UNITED STATES PATENT AND TRADEMARK OFFICE

APPLICATION NO.	FILING DATE	FIRST NAMED INVENTOR	ATTORNEY DOCKET NO.	CONFIRMATION NO.
10/797,839	03/10/2004	John R. Blake	47171-00390USPT	5664
41230	7590	05/24/2007	EXAMINER	
CUMMINS-ALLISON CORP. C/O JENKENS & GILCHRIST 225 WEST WASHINGTON STREET, SUITE 2600 CHICAGO, IL 60606			MCCLAIN, GERALD	
ART UNIT		PAPER NUMBER		
		3653		
MAIL DATE		DELIVERY MODE		
05/24/2007		PAPER

Office Action Summary	Application No.	Applicant(s)
	10/797,839	BLAKE ET AL.
Examiner	Art Unit	
Gerald W. McClain	3653

DETAILED ACTION

FIG. 4

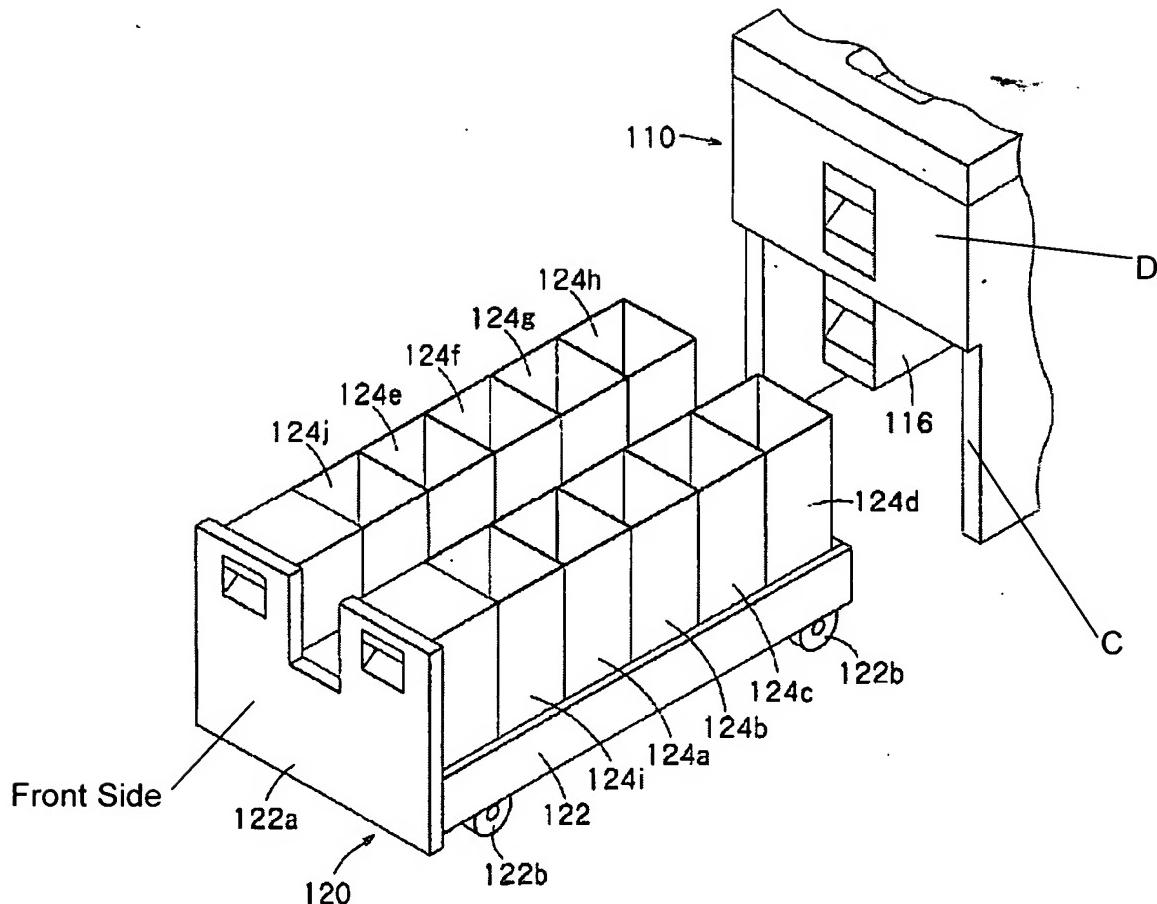
Claim 1: housing (See FIG. 2, 110); coin sorter (S); input hopper (112); rotatable disk (2); stationary head (1); lower surface ([0137]); shaped regions (10); exit channels (8a to 8c); coin receptacle station (120); coin receptacles (124a to 124j); first position (FIG. 2); second position (FIG. 4); manifold (location of 152); coin paths (152); dampening mechanism (See FIG. 4 below, C and 122a);

Claim 4: dampening mechanism (See FIG. 4 below, C and 122a); coin receptacle station (120); first end (See FIG. 4 below, C); housing (110); second end (See FIG. 4 below, Back Side (opposite Front Side) of 122a).

Claim 15: door (122a); rear side (See FIG. 4 below, D); housing (See FIG. 2, 110);

Claim 16: door (122a); front side (See FIG. 4 below, D; Note: the location of D can be defined as the rear or front side); housing (See FIG. 2, 110);

In order to "stop movement of drawer 122", the front wall 122a must dampen drawer 122 at some point between the first and second position. Therefore, 122a is the "dampening mechanism".

It is inherent that the first (C) and second (rear face of 122a) ends are "coupled" as shown in FIG: 2 and 4. As shown in the figures, the ends are coupled since they come into contact with each other.

The wall is a door since it is a "movable panel (122a in FIG. 2 and 4) for closing off an entrance (See FIG. 4, opening near 116)." (Webster's II Dictionary, Office Edition, 3rd ed., Houghton Mifflin Company, 2005)
